**From:** Scala, Mary Joy  
**Sent:** Monday, June 09, 2014 2:51 PM  
**To:** 'Andrew Brown'  
**Cc:** Cecilia H. Nichols; Thomas Woltz; Mike Gallahue  
**Subject:** RE: Locust Ave - windows

**From:** Andrew Brown [mailto:[andrew@formworkusa.com](mailto:andrew@formworkusa.com)]  
**Sent:** Monday, June 09, 2014 2:42 PM  
**To:** Scala, Mary Joy  
**Cc:** Cecilia H. Nichols; Thomas Woltz; Mike Gallahue  
**Subject:** Locust Ave - windows

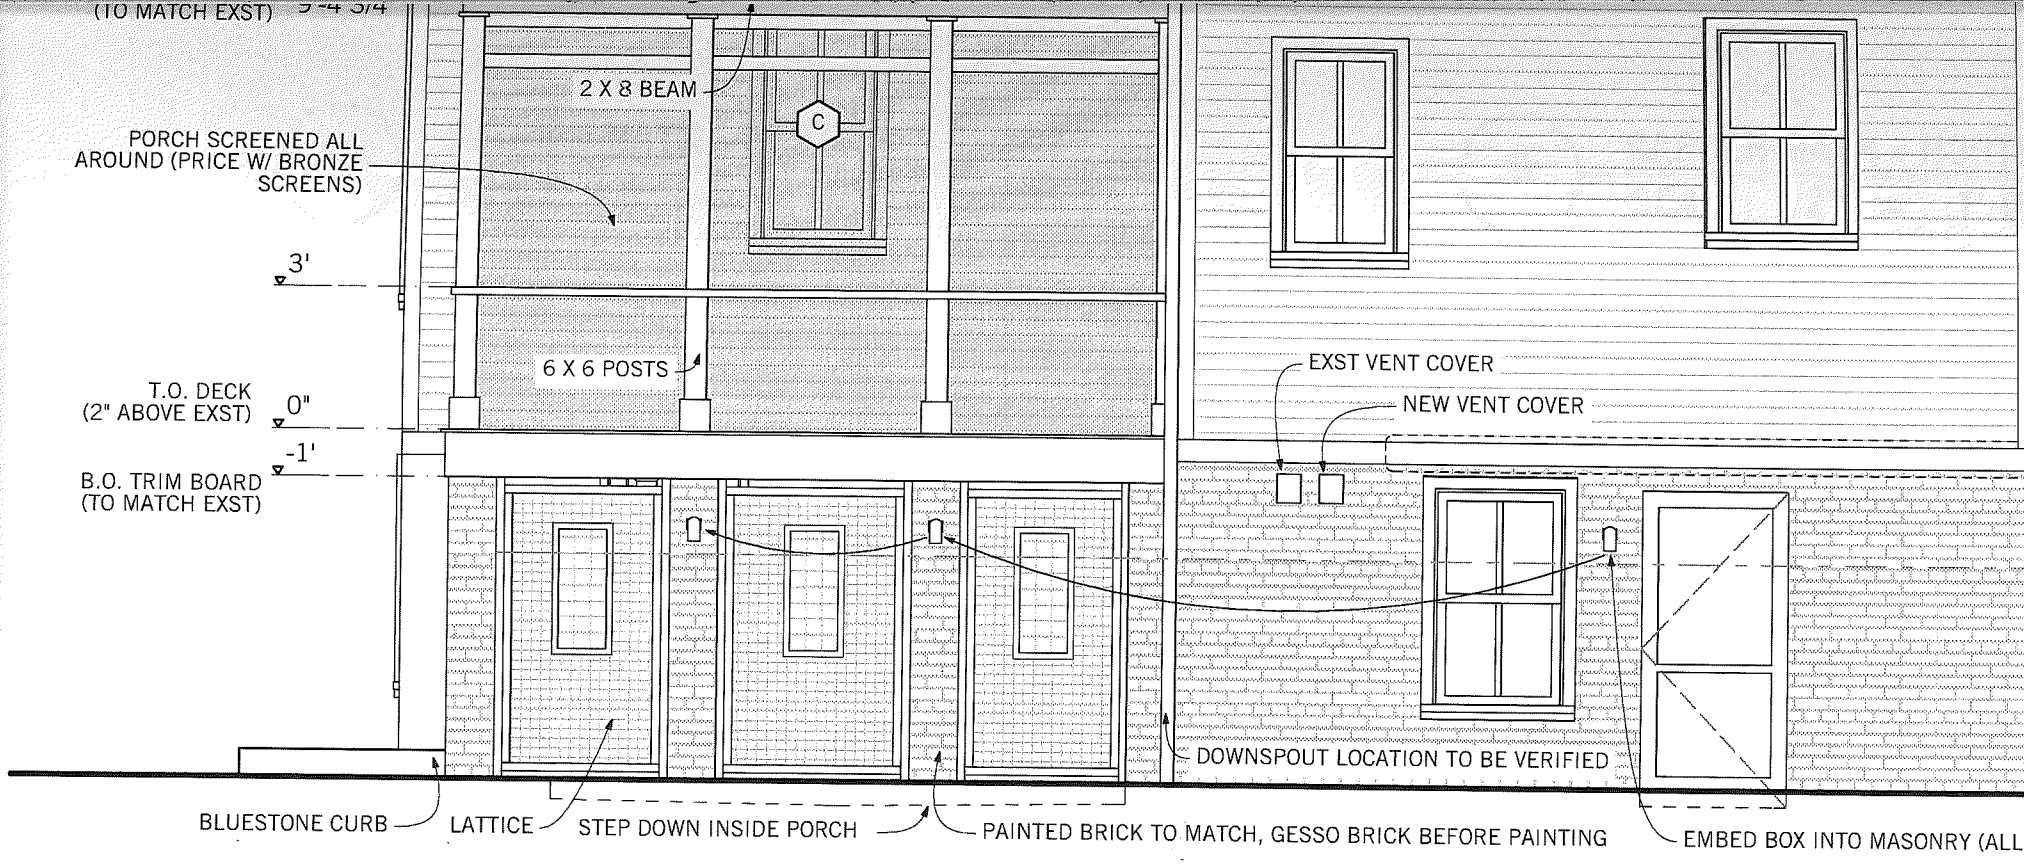
As you know, we are proposing replacement of some of the existing windows at 867 Locust Ave. All windows will be replaced maintaining the same dimensions as the originals with the exception of the east window in the dining room. This window was originally the same dimension as the rest of the windows in the that room, but in early 2000 the window was replaced with a three-panel window which lowered the sill to the floor. We are proposing replacement of this window with a double hung in order to restore the opening to its original scale and dimension. Please let us know if there is any other information you need.

Thank you for the additional information. Because you are restoring the window to its original dimensions, I believe that meets the intent of the ordinance. You do not require further approval from the Board of Architectural Review, and you may proceed to apply for your building permit.

**1** ELEVATION - EAST  
SCALE: 1/4" = 1'-0"

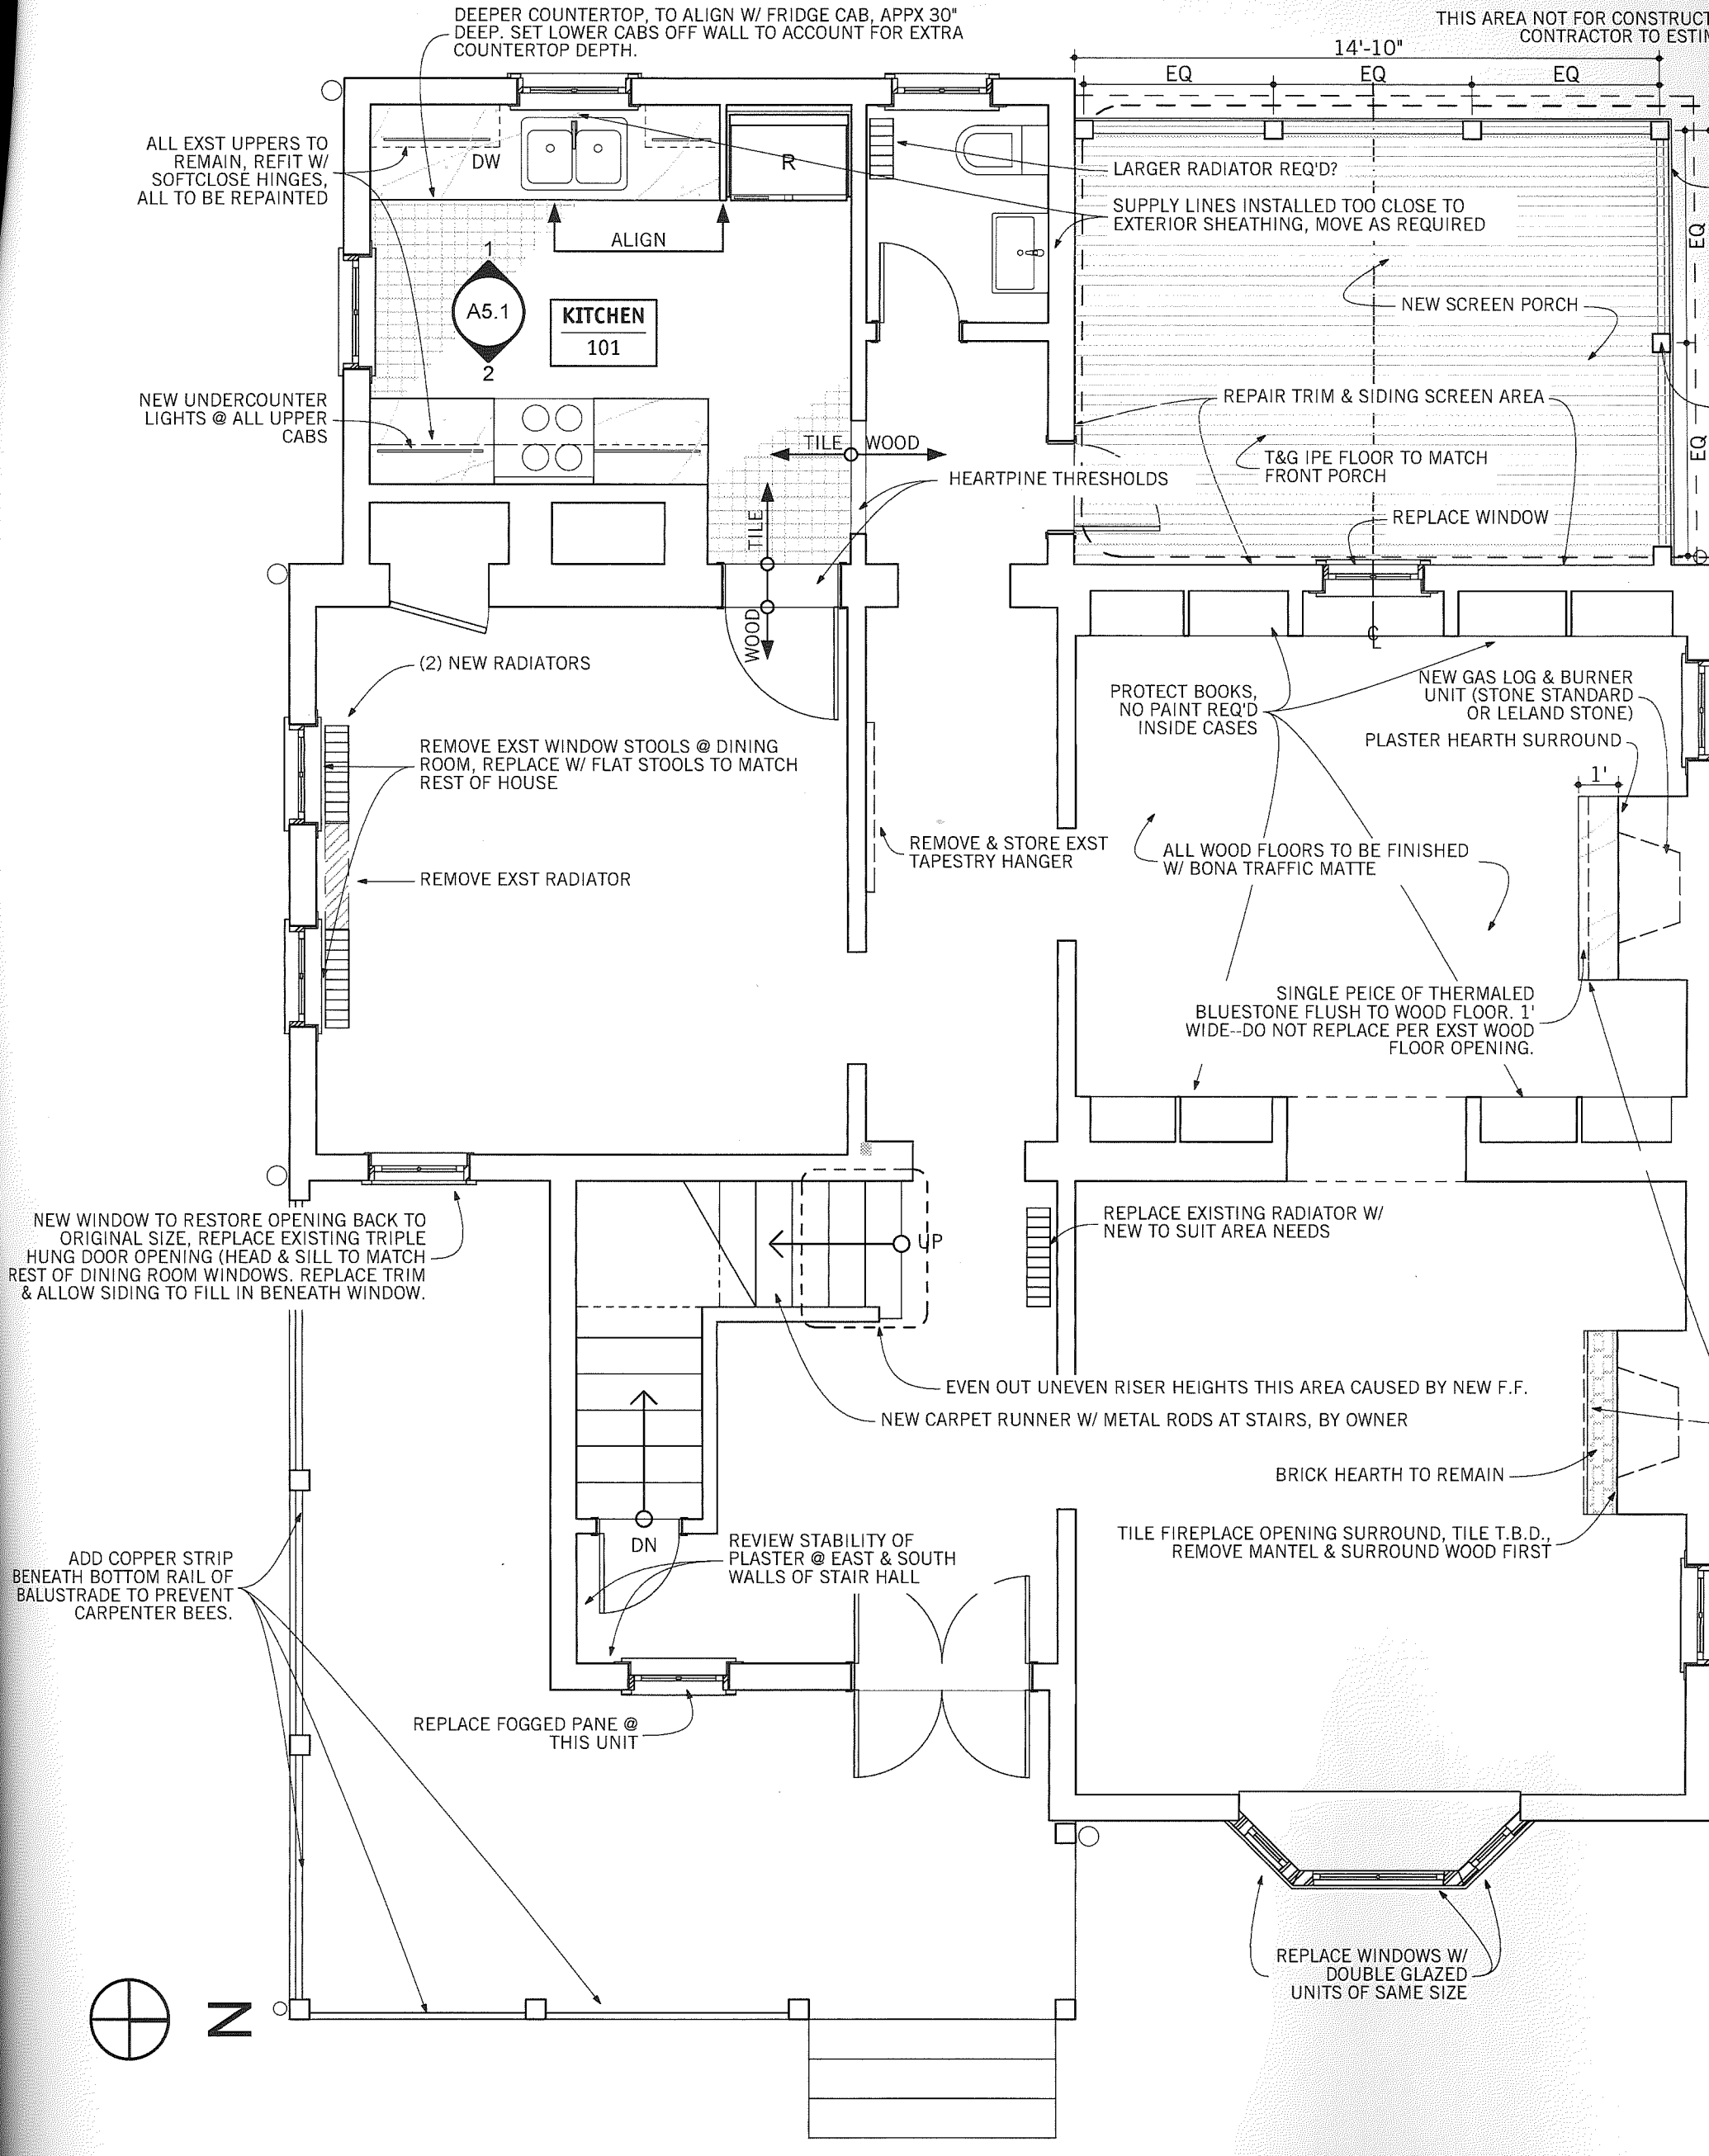
NEW WINDOW TO RESTORE OPENING BACK TO ORIGINAL SIZE, REPLACE EXISTING TRIPLE HUNG DOOR OPENING (HEAD & SILL TO MATCH REST OF DINING ROOM WINDOWS. REPLACE TRIM & ALLOW SIDING TO FILL IN BENEATH WINDOW.
